1. Additional Wetland Impact Minimization – the proposed plans in the application were designed as a maximum extent for identified wetland impacts. Now that we are further along in the process with some more detail refinement, the application will need to include an updated plan and identify where there are others of further wetland impact minimization.

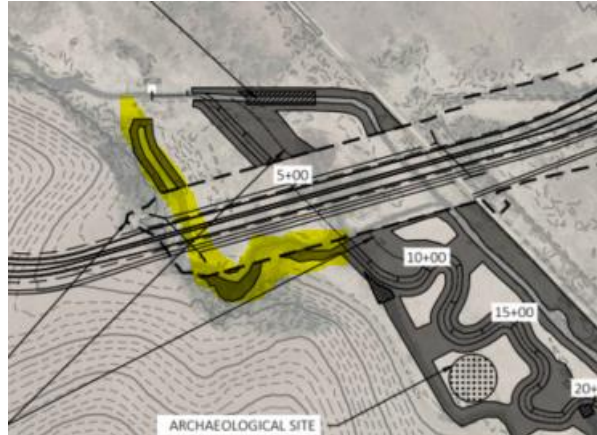
- a. There was information brought to our attention about existing springs located on the west side of the river valley at the approach for the bridge. This section (highlighted in yellow in the image below) was not included in the stream restoration but there is concern that existing active springs would be significantly impacted by the construction of a bridge and abutment.

- i. **Next steps:** Please provide a map identifying the springs and a revised restoration (realignment) design to include the active springs and the flow to be incorporated into the restoration. If the springs are located completely south of the proposed abutment, then identifying the springs is needed on an updated plan map showing a flow path to ensure the flow from the springs will reach the new realigned stream channel. If the springs are located north of the proposed abutment, then the stream restoration will need to accommodate and incorporate the springs and flow (which likely requires bridge design adjustments) to ensure the springs remain open and are part of the river system.

An updated stream restoration sheet has been provided identifying the location of the springs which will be connected as part of the main Sugar River channel. By relocating the main channel from the previous location, it is now preserving the springs by intercepting the spring flows to ensure they remain open and part of the river system. The restoration plan has been revised as well with the updated stream remeandering location.
